GEORGIA INSTITUTE OF TECHNOLOGY

AMENDMENT TO FACILITY OPERATING LICENSE

Amendment No. 11
License No. R-97

ENCLOSURE TO LICENSE AMENDMENT NO. 11

Figure 6.1 Georgia Tech Organization for Management and Operation of the GTRR. (Amendment 11).

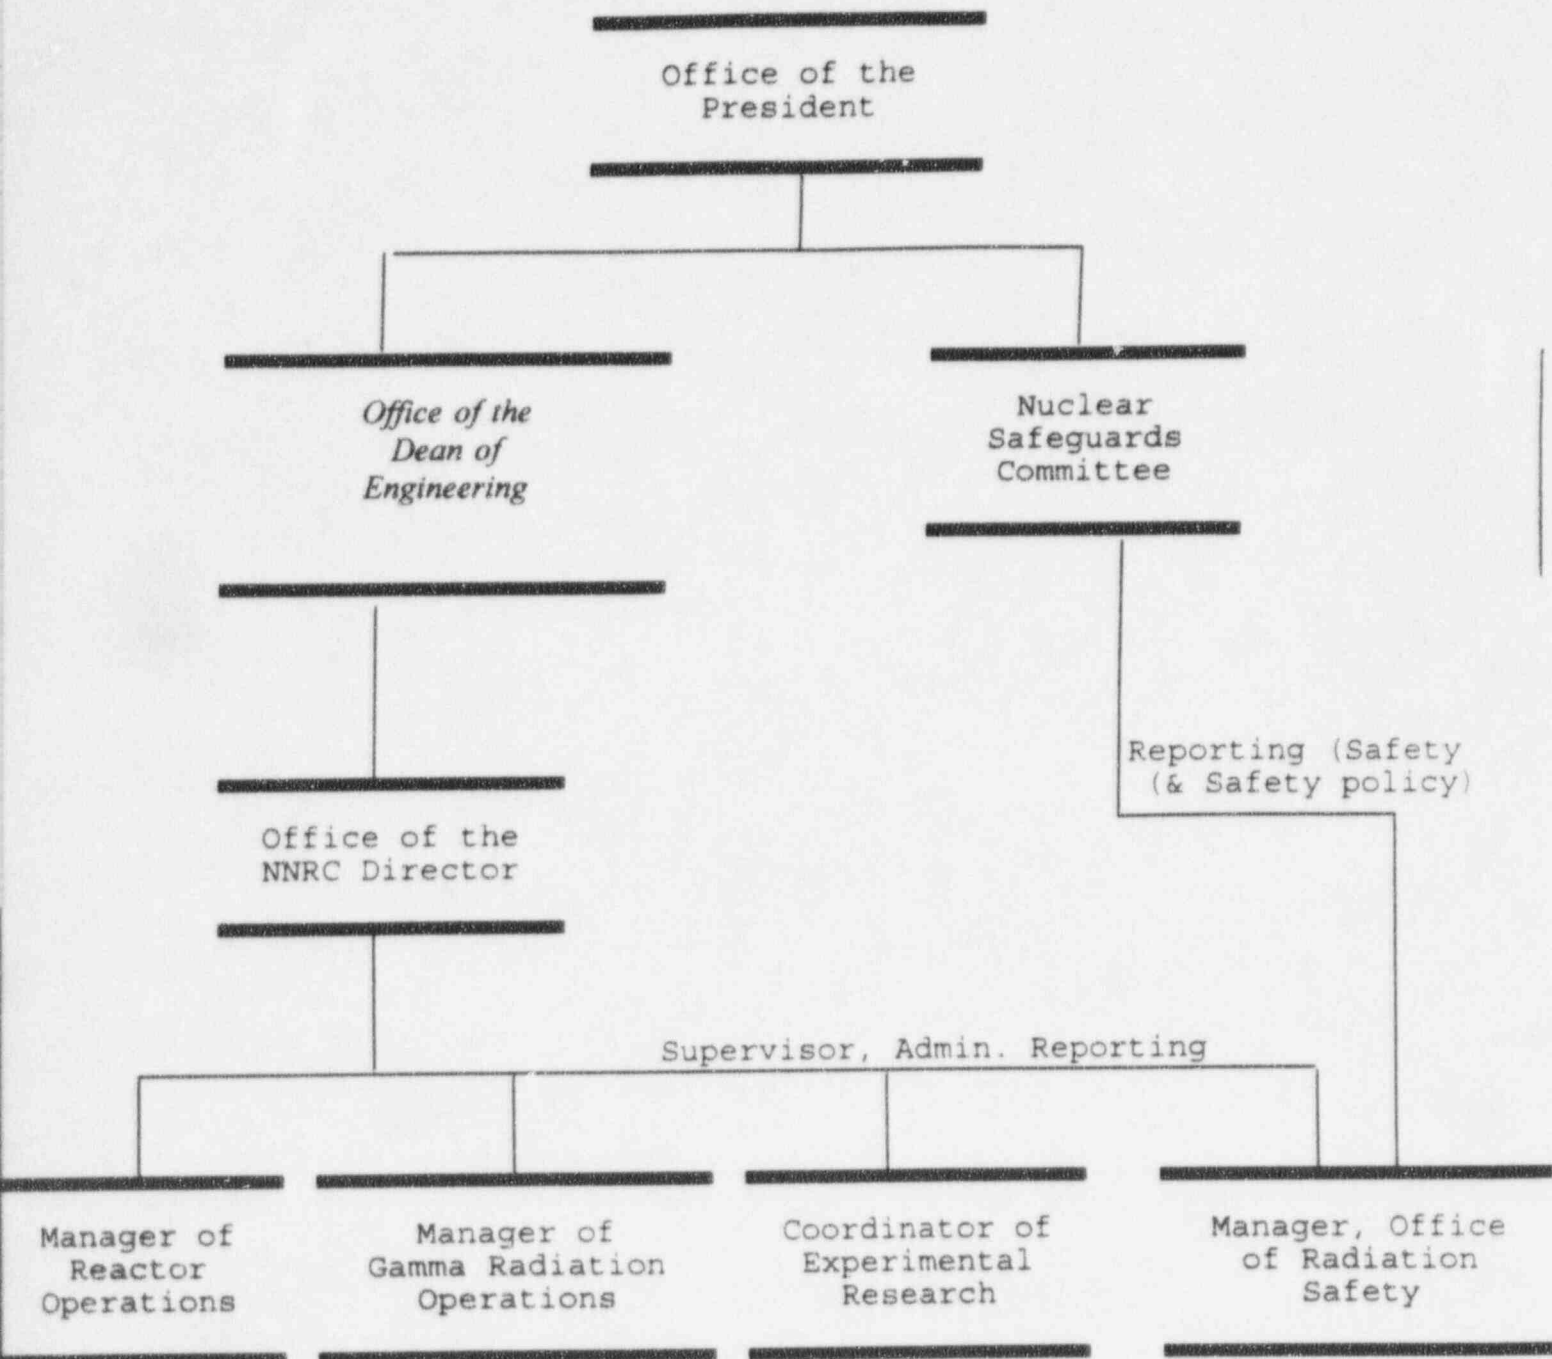
- a. The organization for the management and operation of the reactor shall be as indicated in Figure 6.1. The Director, Nuclear Research Center, shall have overall responsibility for direction and operation of the reactor facility, including safeguarding the general public and facility personnel from radiation exposure and adhering to all requirements of the operating license and Technical Specifications.

- b. The Manager, Office of Radiation Safety, shall advise the Director, Nuclear Research Center, in matters pertaining to radiological safety. He/she has access to the Dean of Engineering and/or the President of the Institute as needed.
